The Commission has issued the enclosed Amendments Nos. 58 and 25 to Facility Operating Licenses Nos. DPR-51 and NPF-6 for Arkansas Nuclear One, Units Nos. 1 and 2, respectively. These amendments consist of changes to the Technical Specifications in response to your application dated January 30, 1981.

These amendments modify the ANO-1&2 Appendices A and B Technical Specifications to change organization and personnel titles within Arkansas Power and Light Company.

ARKANSAS NUCLEAR ONE - UNIT NO. 1

ARKANSAS NUCLEAR ONE - UNIT NO. 2

Figure 6.2-1 Management Organization Chart

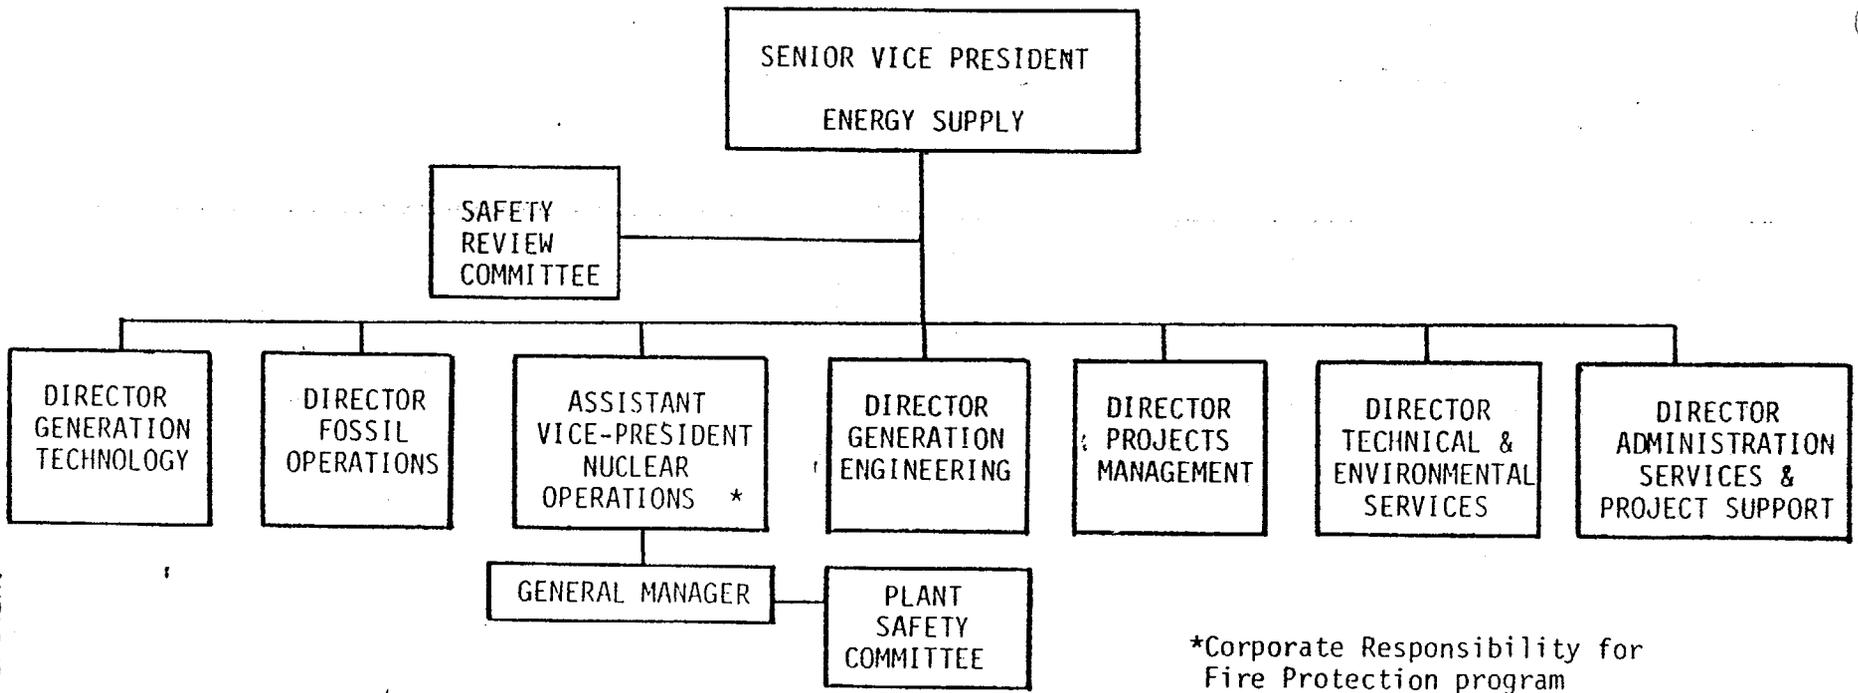
The proposed change in organizational structure would change the title of Vice President, Generation & Construction, to Senior Vice President, Energy Supply, and the title of the Director, Nuclear Operations, to Assistant Vice President, Nuclear Operations. The proposed change would involve no change in the function of these two officers relating to the operations of ANO-1&2. The proposed change is administrative in nature and would not involve a decrease in the margin of safety or an increase in the probability or consequences of accidents. Therefore, we find the proposed amendments acceptable.
